MFN 10-044 Supplement 1 Revision 1

Docket No. 52-010

Subject: **Revised Response (Revision 1) to NRC Request for Additional Information Letter No. 411 Related to ESBWR Design Certification Application – Engineered Safety Features – RAI 6.2-202 Supplement 1**

**Revised Response (Revision 1) to NRC Request for
Additional Information Letter No. 411
Related to ESBWR Design Certification Application**

Figure 6.2-202 M1

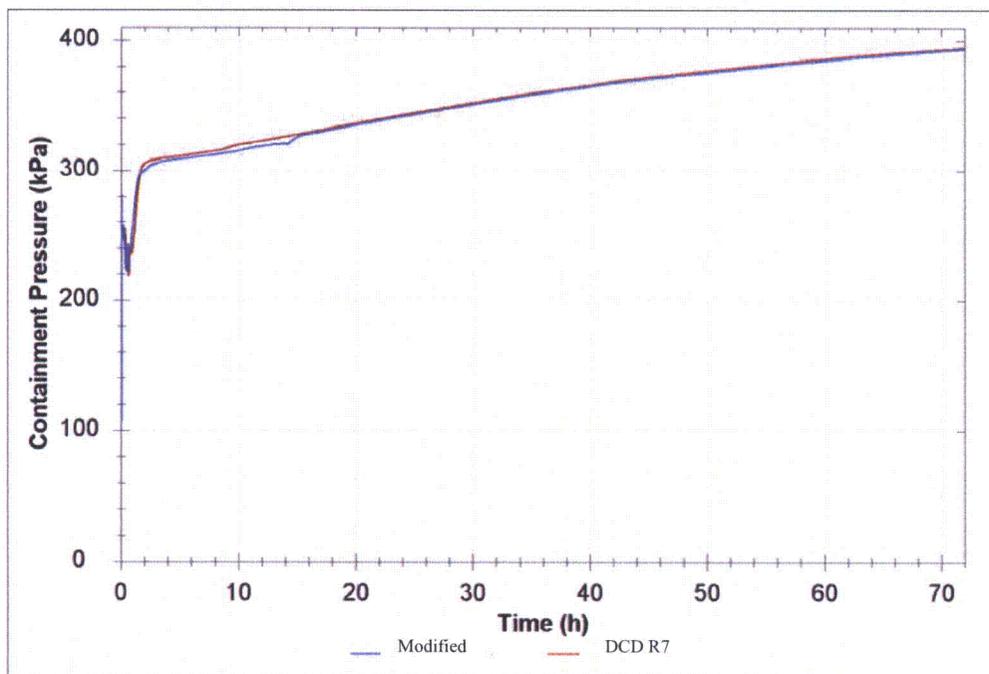
The results of the TRACG analysis that includes the change in tube material, number of tubes, tube thickness and tube inner diameter is presented in Figures 6.2-202 M1 and 6.2-202 M2. Figure 6.2-202 M1 presents the containment pressure response for the updated TRACG analysis vs. the containment pressure for the TRACG analysis in the DCD Tier 2 R7 Figure 6.2-14j1. They are approximately the same and the modified analysis has a slightly lower maximum pressure than the DCD Rev 7 analysis. Figure 6.2-202 M2 presents the PCCS power for the updated TRACG analysis. The PCCS power is similar to the PCCS power presented in the DCD Tier 2 R7 Figure 6.2-14i1 (Figure 6.2-202 M3). The difference in the curves in each of these figures is due to uncondensed steam flowing to the wetwell from the drywell in the early blow down and from the PCCS in the long term. The figures show that the difference between the decay heat and PCC power in the LOCA transient is similar for the DCD Rev 7 and modified design.

As seen in Figure 6.2-202 M1, the changes to the PCCS did not affect the TRACG results for containment pressure. The updated analysis shows that the long term LOCA response remains approximately the same as the previous analysis. This is because the wall thermal conductivity decrease offset the surface area increase. The PCCS continues to operate below its 100% steam capacity rating (47 MW total rated capacity for 6 PCCS condensers) in the long term (6-72 hour period) DBA LOCA as indicated by the Total PCCS Power in Figure 6.2-202 M2. It is operating below its 47 MW (7.8 MW per unit) capacity during the DBA LOCA. The integral PANDA tests included all of the features required for an integral system simulation for a long term LOCA response. Figure 6.2-202 M2 shows the PCCS power, which in comparison to the DCD R7 PCCS

Figure 1c: PCCS Condenser ASME Jurisdictional Boundaries

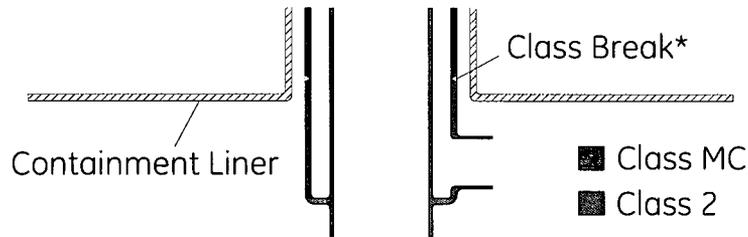
AA. LTR NEDE-33572P Rev. 1, Section 3.2 - Per Figure 1c, a portion of the drain pipe below the lower drum nozzle is classified as class MC. Table 3-1 must clarify this ASME class change.

Per Figure 1c, a portion of the drain pipe below the lower drum nozzle is classified as class MC. Table 3-2 indicates the design pressure for this portion is 0.407 MPa. Technical basis should be provided for using this design pressure and not 38.7 MPa used in the lower drum design.

Table 3-1 of the LTR will be revised to clarify that the drain pipe contains both NC and NE portions, consistent with figure 1c.
